An Bord Pleanála Oral Hearing

Irish Water Greater Dublin Drainage

Response to Noise and Vibration Questions

Response to issues raised in Fingal County Council Statement of 22 March 2019

R3 (Table 15.12) in the assessment. An extract from Figure 14.4 is shown below to indicate where the Hospice is relative to Connolly Hospital and the elements of the proposed Project.

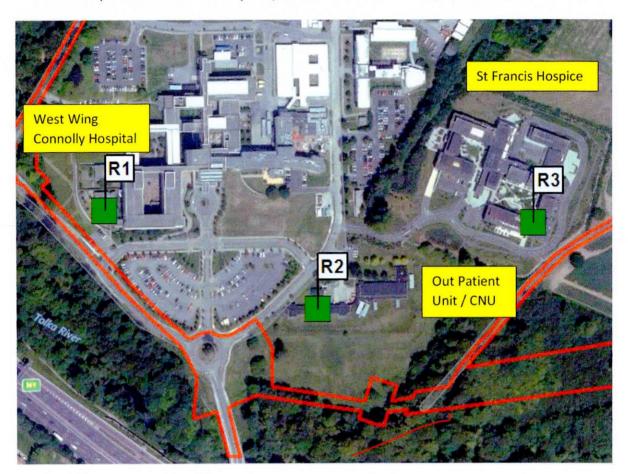
(21) The Inspector has requested that information be provided about the assessment of impact on St Francis Hospice. The construction phase noise and vibration impact on St Francis Hospice is assessed in section 15.4.2 and section 15.4.4 of the EIAR. Noise monitoring for baseline assessment was carried out at the Hospice (Table 15.9) and this noise sensitive receptor (NSR) was included as

- (22) The construction phase noise impacts on the Hospice were addressed as follows:
 - (i) Construction Phase noise impacts of the proposed Abbottstown Pumping Station on St Francis Hospice were shown in Table 15.15 to be significantly lower than the adopted and permissible standards for daytime works; no night time construction works for these elements of construction are proposed.

- (ii) The potential noise impacts associated with construction of the proposed Orbital Sewer at St. Francis' Hospice was specifically included in the impact assessment even though it is located a considerable distance from the proposed orbital sewer route, as this location is considered to have an increased sensitivity to noise impacts. The noise impact for these works was assessed in Table 15.23 where the maximum predicted impact for construction activity was determined to be less than 60dB(A) LAeq.1hr outside the building, which is very significantly lower than the permissible 70dB(A) LAeq.1hr standard for weekday and 65dB(A) LAeq.1hr work on Saturdays.

- (iii) The assessment of the potential noise impact of micro-tunneling on the Hospice was considered in Section 15.4 under the heading "Trenchless Works (Micro-tunneling)". It was noted in this section of the EIAR that tunnelling works would be required in the grounds of Connolly Hospital over a length of approximately 1km. In the assessment, a screening exercise identified the closest receptors that could be affected by the proposed micro-tunneling works, and specifically for the Connolly Hospital works the

distance between the identified receptors and the closest boundary of the most significant elements of the works (the construction compound for the launch shaft of the tunnel) is noted in Table 15.25 of the EIAR as being 45m.

- (iv) It is noted that the closest distance to the microtunneling works is 45m from the West Wing of Connolly Hospital and 65m from the Outpatient Unit (which is the approximate future location of the Community Nursing Unit). Predicted noise levels for the different aspects of the microtunnelling works are presented in Table 15.26 of the EIAR (Launch shaft construction works), Table 15.28 of the EIAR (tunnel boring machine construction works daytime), Table 15.29 of the EIAR (tunnel boring machine construction works night-time) and Table 15.30 of the EIAR (groundborne noise levels associated with microtunnelling). These tables show that the adopted standards for day and night time works will be met for each element of the microtunneling works at each of the listed locations.

- Although not specifically stated in these Tables, the noise impacts will be lower than (v) those presented in these Tables for the St Francis Hospice which is located further away from the orbital sewer than these identified locations (over 80m from the closest point of the Orbital sewer and 220m from the Pumping Station). With the standard mitigation measures identified in the EIAR, the predicted daytime noise levels at the closest Hospice location would range from 46dB LAeq to 54dB LAeq depending on the microtunnelling works occurring compared to the adopted standard of 70dB LAeq,1hr at the external facades of the building. The predicted night-time noise levels at the closest Hospice location would range from 24dB LAeq to 44dB LAeq depending on the microtunnelling works occurring compared to the adopted standards of 45dB LARG, 1hr at the external facades of the building. Noise levels reduce by approximately 15decibels through an open window and 20 to 45 decibels through a closed window (depending on the type) so the internal noise levels would be less than 29dB(A) and 19dB(A), respectively, for day and night time construction works. Both of these levels are below the recommended night time indoor level of 30dB(A) LAeq adopted for this assessment.
